ALLEGHENY COUNTY SANITARY AUTHORITY

CONTRACT NO. 1729 G, E, H, P

EAST HEADWORKS

ADDENDUM NO. 4

C-22
YARD PIPING PLAN - EAST

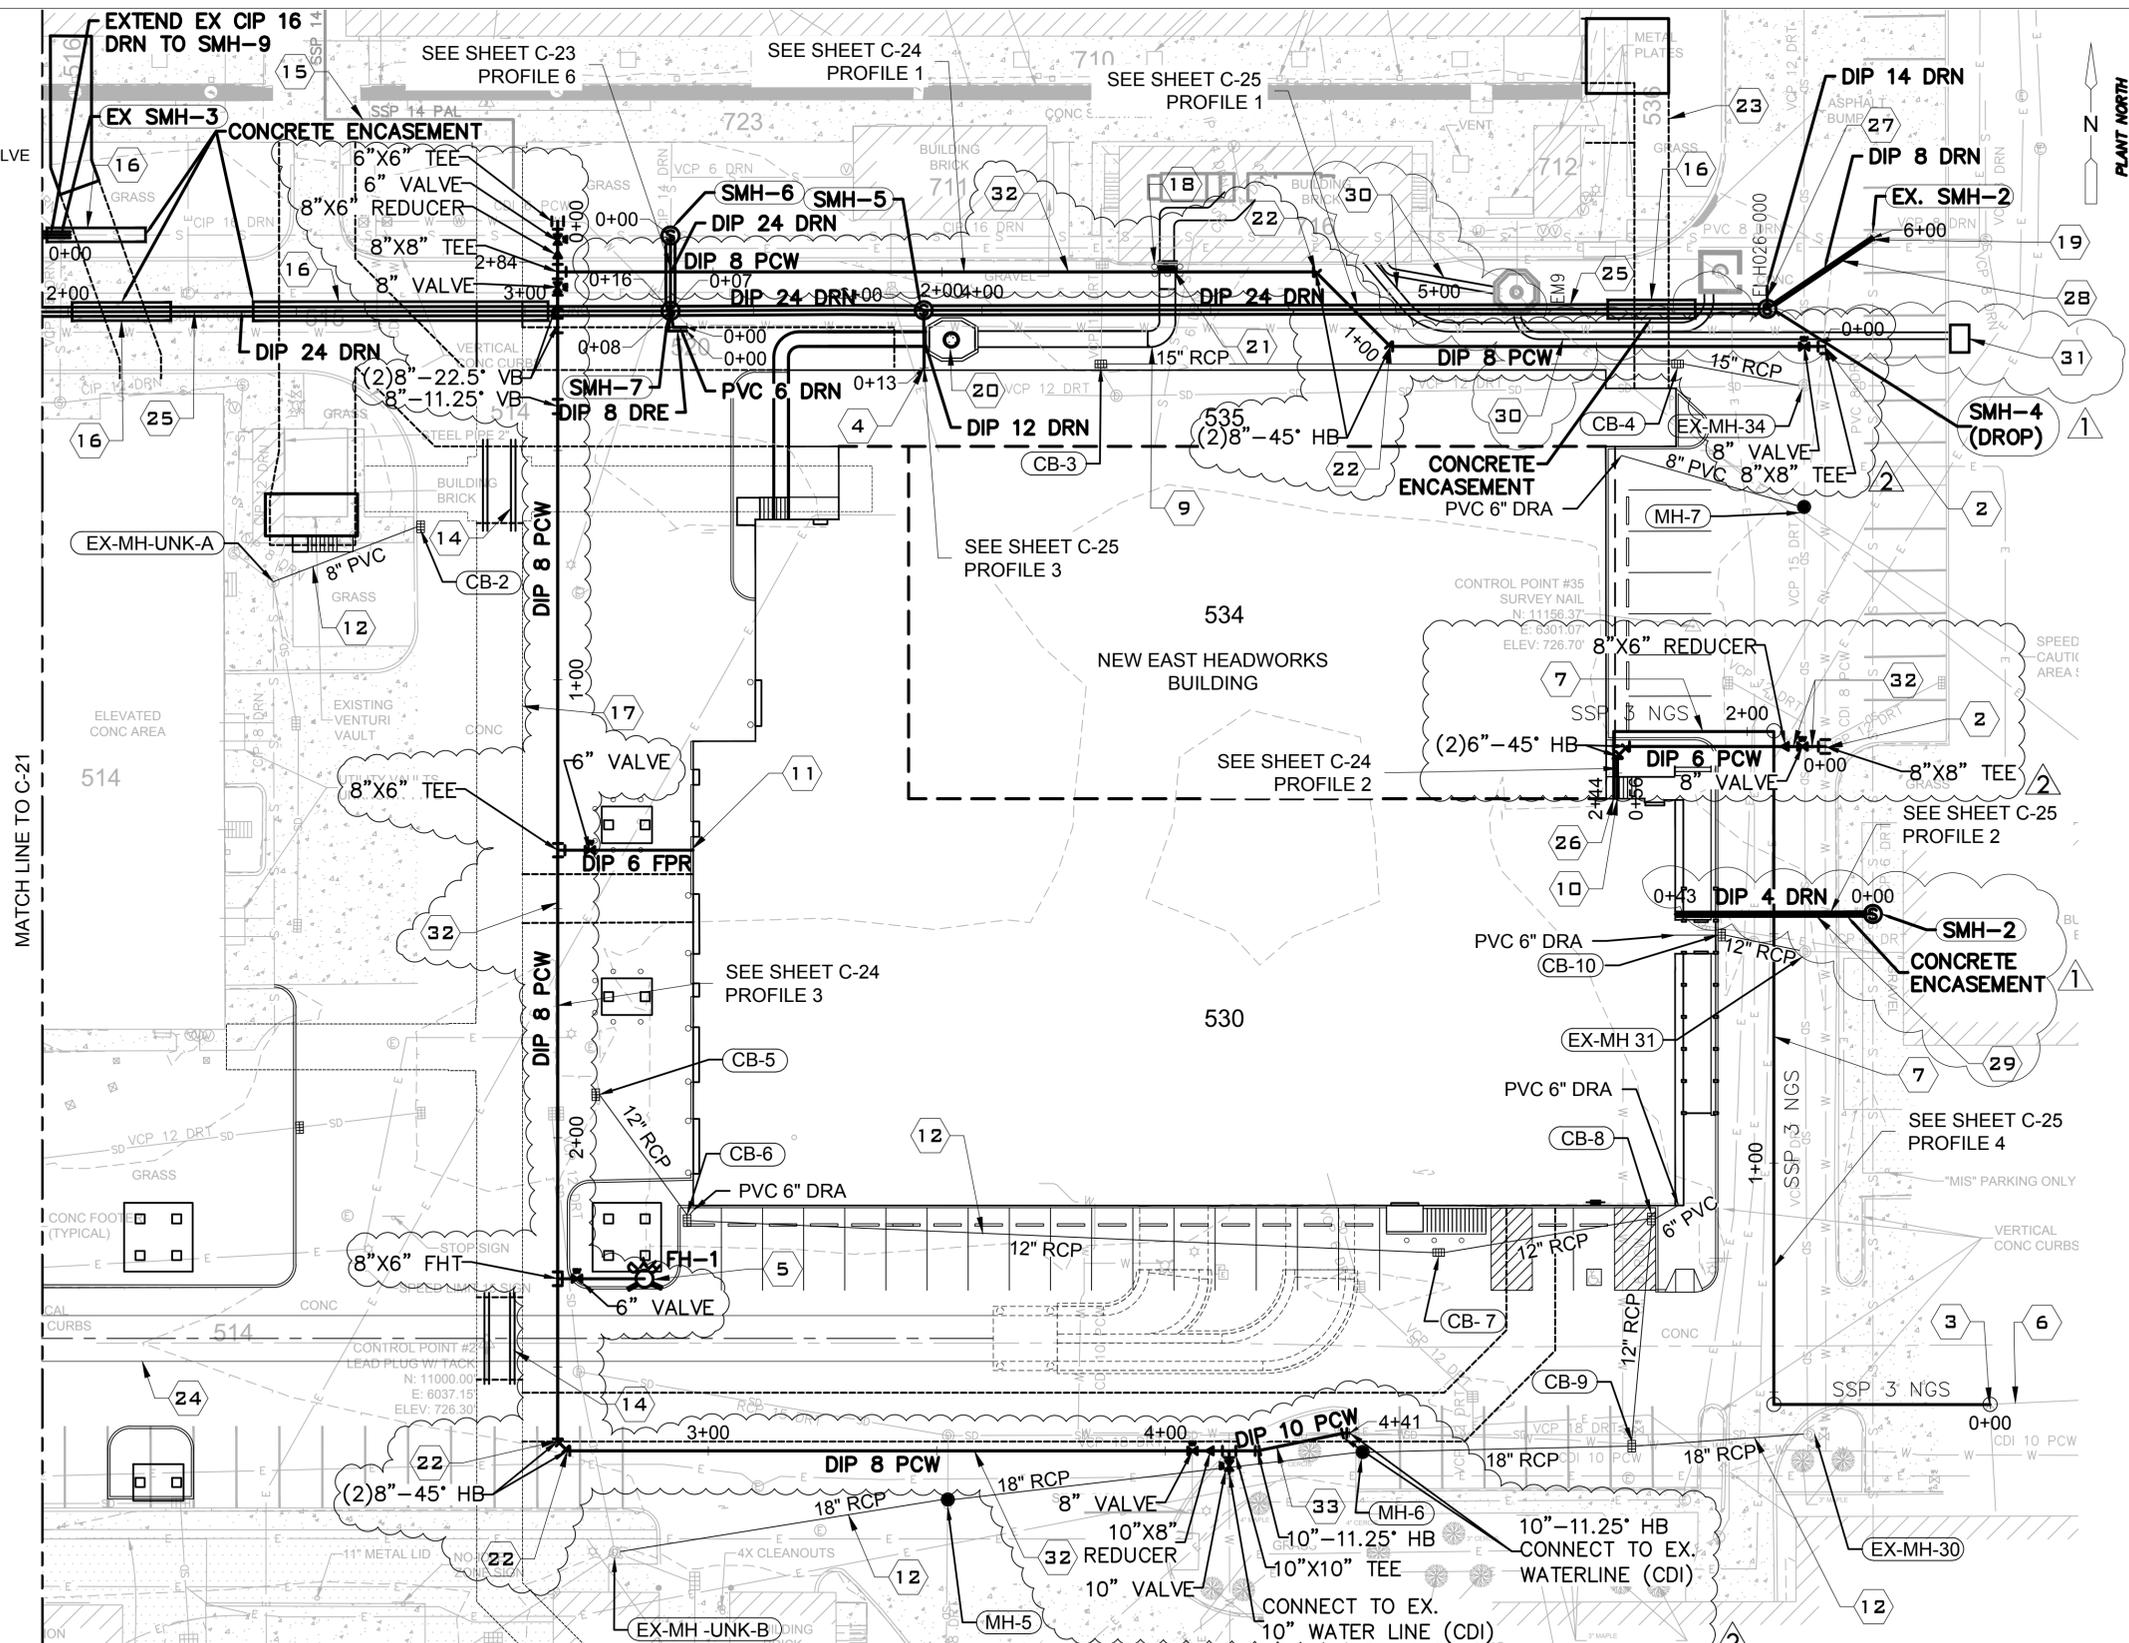
4. Drawing C-22

DELETE this drawing and REPLACE with the attached drawing C-22.

C-24
 YARD PIPING PROFILES

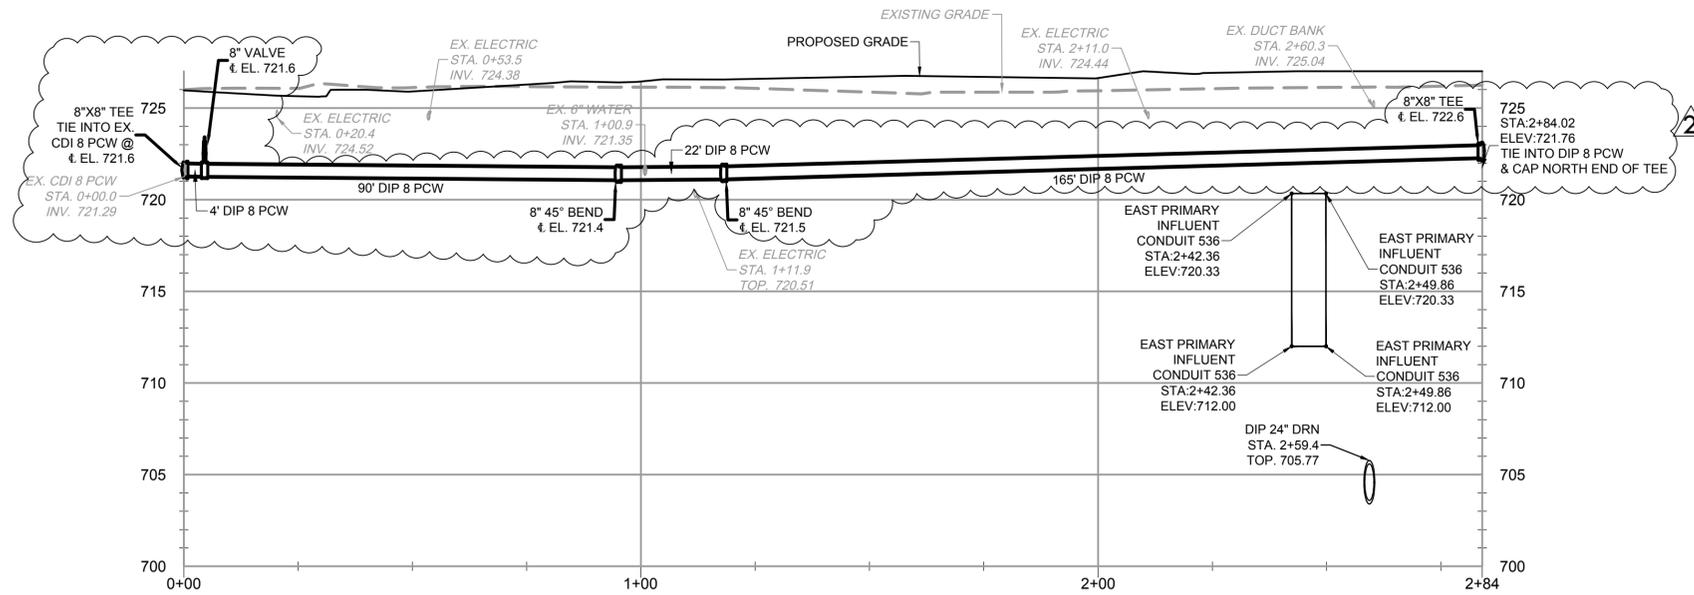
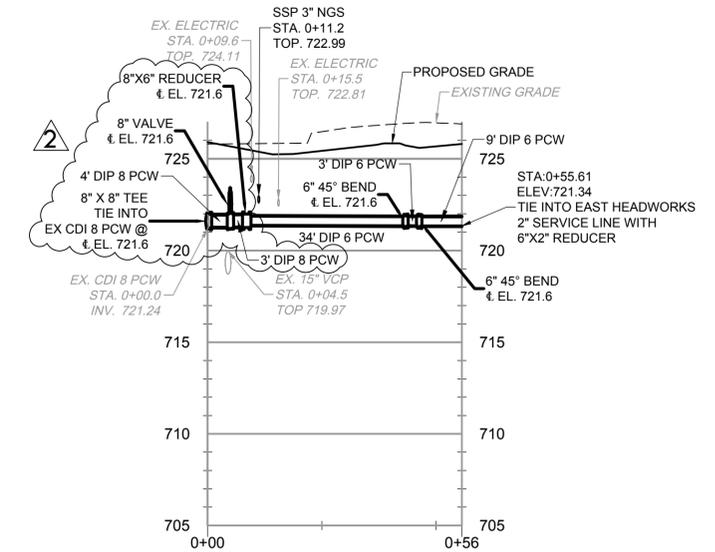
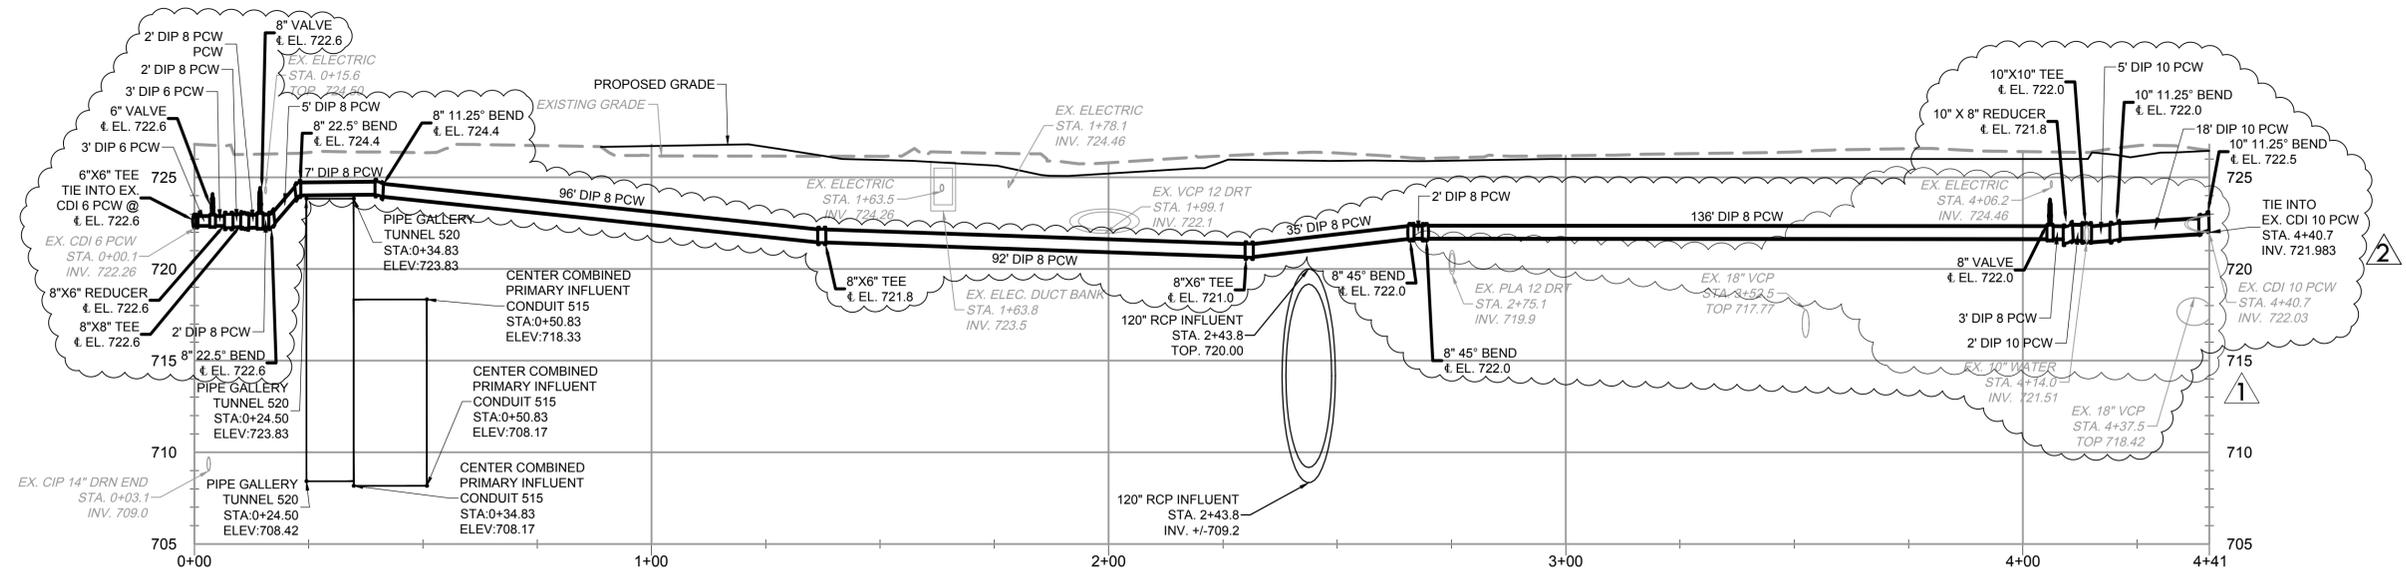
5. Drawing C-24

DELETE this drawing and REPLACE with the attached drawing C-24.
